SUBJECT: Forwards addl info re spent fuel storage capacity expansion program.

Donald C. Cook Nuclear Plant Unit Nos. 1 and 2
Docket Nos. 50-315 and 50-316
License Nos. DPR-58 and DPR-74
Spent Fuel Storage Capacity Expansion Program

July 27, 1979
AEP:NRC:00213A

FIGURE 3.6.14 Mode Shape 1
Plan View On Top Of Rack Module

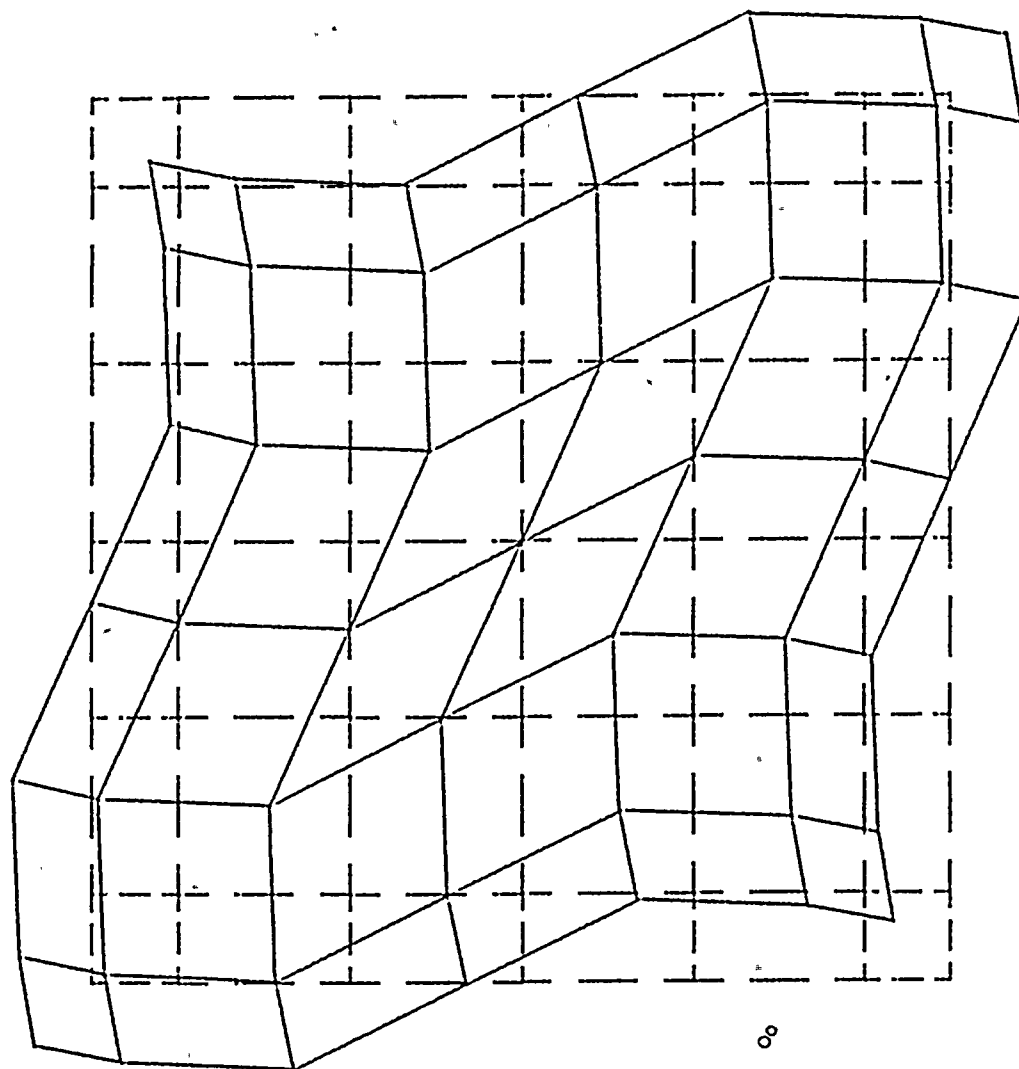
Provide a sketch of the first mode vibration which results from the SAP IV Seismic Model of FIG. 3.6.1. Discuss why, for this mode, the participation factors are so small.

A plot of the first vibrational mode shape is presented in Figure 3.6.14. The mode shape plot is presented as a plan view of the top of the rack structure. As can be seen from Figure 3.6.14 this mode shape constitutes a diagonally symmetrical "diamonding" distortion at the top of the rack.

Since this mode shape is symmetrical all inertial and stiffness forces are balanced within the structure. There is, therefore, a negligible response to seismic excitation imposed at the pool floor/rack base interface.
